SUBJECT: Forwards responses to environ rept review Questions 240.4-9.  
 Ltr supplements 820603 & 0714 responses. Responses to  
 Questions 240.3, 291.13 & 291.15 will be submitted in near  
 future.

SHEARON HARRIS NUCLEAR POWER PLANT  
UNIT NOS. 1 AND 2  
DOCKET NOS. 50-400 AND 50-401  
ENVIRONMENTAL REPORT REVIEW QUESTION RESPONSES

Carolina Power & Light Company's responses to the Shearon Harris Nuclear Power Plant (SHNPP) Environmental Report (ER) review questions numbered 240.4, 240.5, 240.6, 240.7, 240.8 and 240.9 are attached. This letter supplements our responses of June 3, 1982 and July 14, 1982.

PIEZOMETRIC MAP OF THE PLANT ISLAND VICINITY ON JUNE 17, 1982

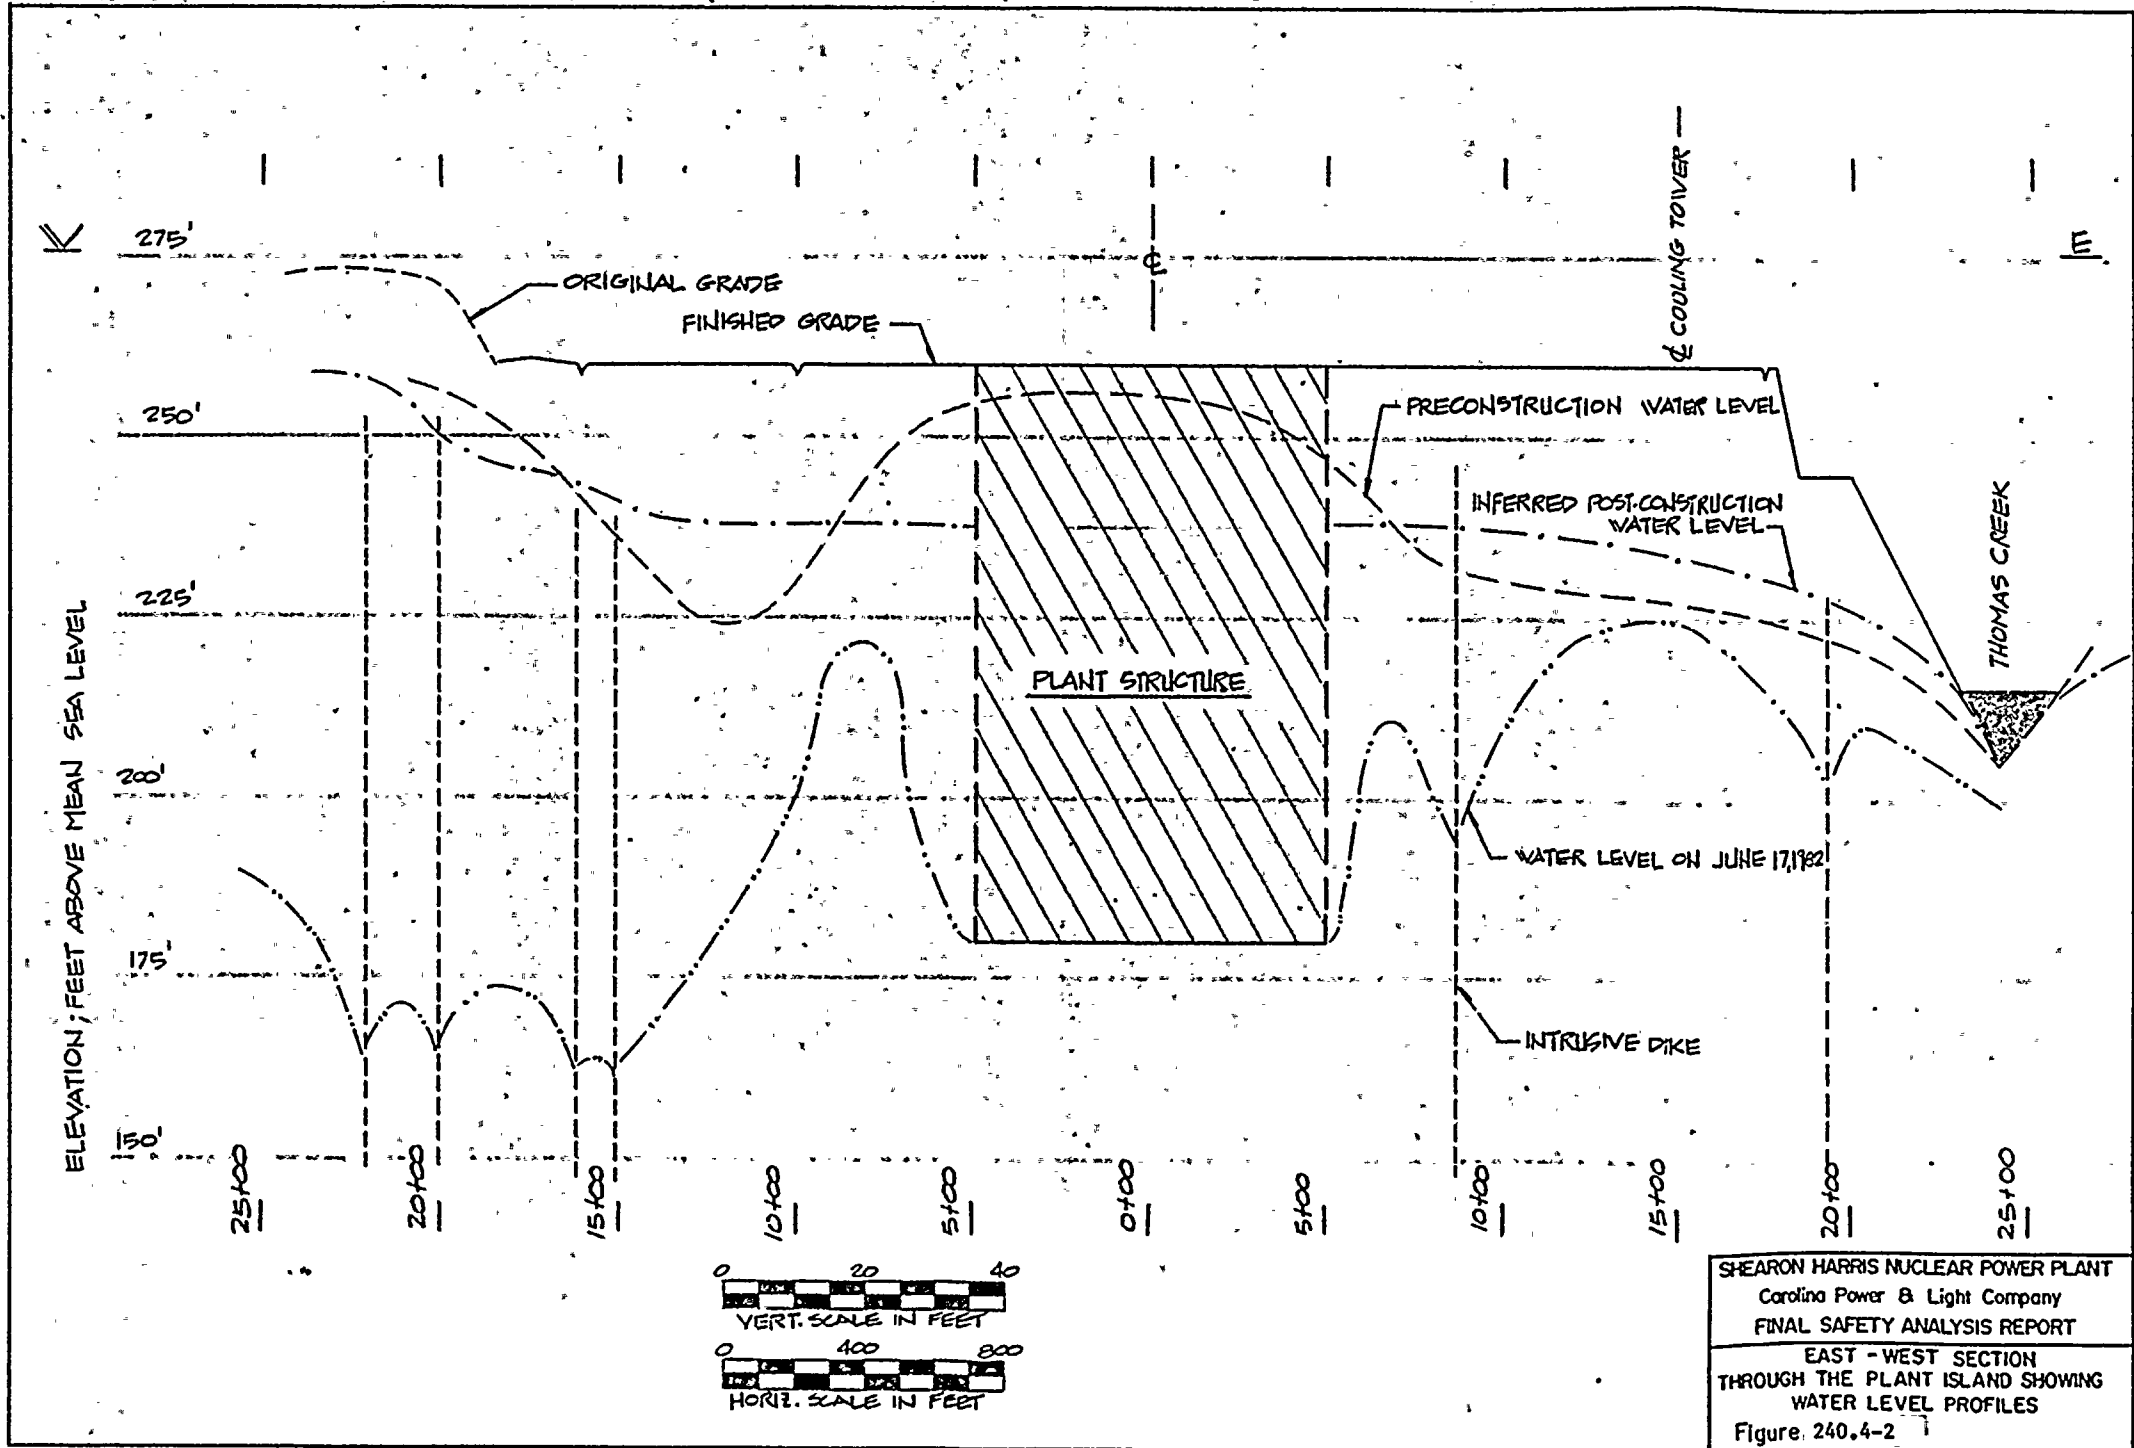
Provide a discussion of the effect of the reservoir on offsite groundwater levels. In your discussion include a piezometric level map showing preconstruction groundwater level and expected increases relative to ground surface elevation for affected offsite areas. Also describe how the water level increases were determined including assumed permeabilities, flow net and etc.

Because of the impervious nature of the soils and country rock, there is only insignificant interchange of water between the reservoirs and the aquifer. This condition is verified as shown in Figure 240.4-1. Note that the water levels in piezometers 8A and LP13 are at elevations 102.5 ft. (affected by pumping) and 189.3 ft., respectively, while the water level in the emergency intake canal, approximately 50 feet from both wells, is at elevation 245 ft.
